Addendum No. 01

File No. 43-41

DSA Appl. No. 01-122194

Project: Hayes Elementary School Repaving
2035 Poston Drive
San Jose, CA 95136
Oak Grove School District

Hayes Site Map – Coring results.

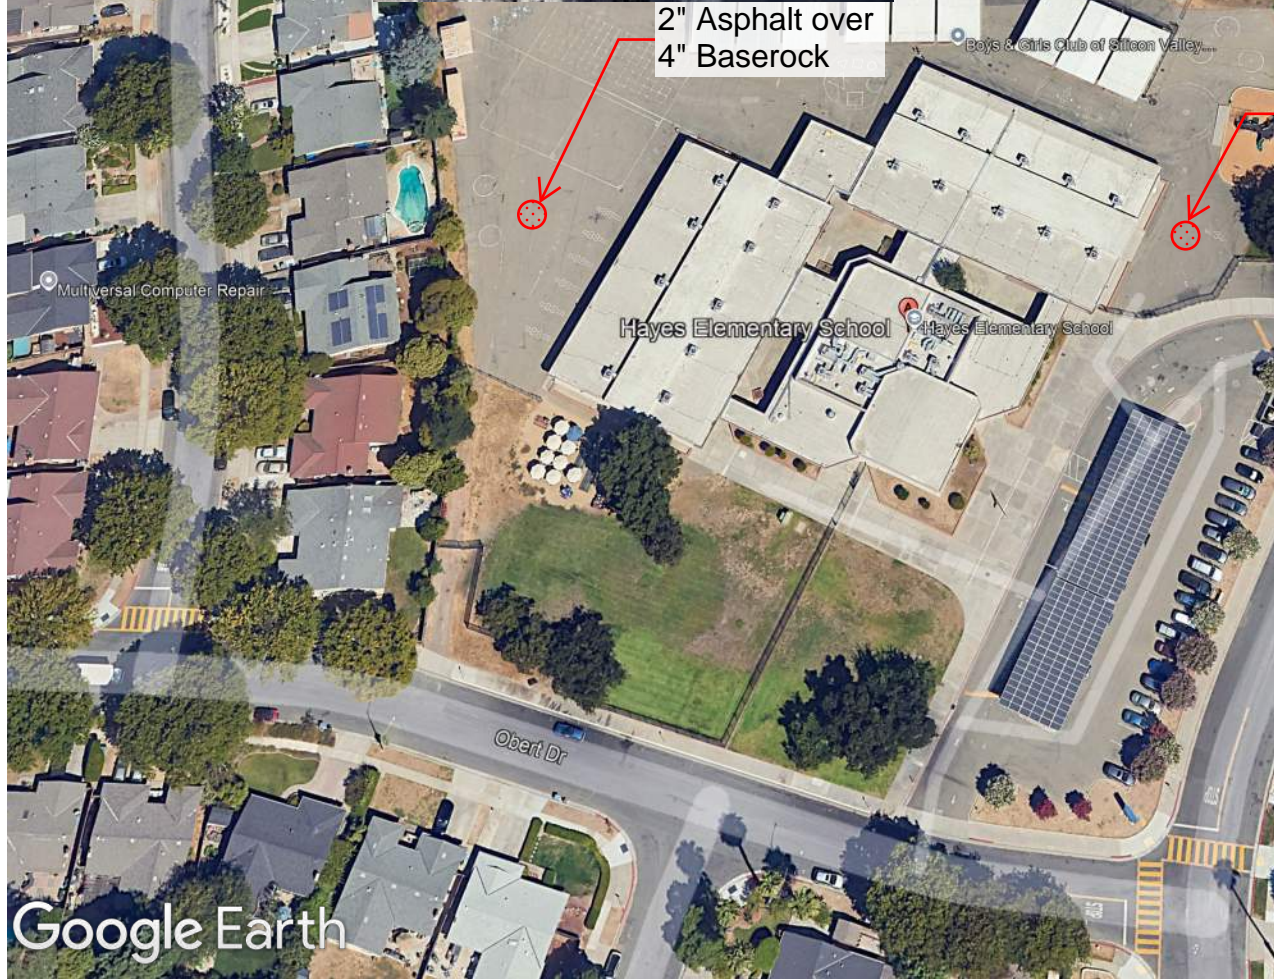
C6: Does the District have a geotechnical report for this site?

2" Asphalt over
4" Baserock

2" Asphalt over
2" Baserock

A6: No. Please see the attached coring's to show existing thickness.
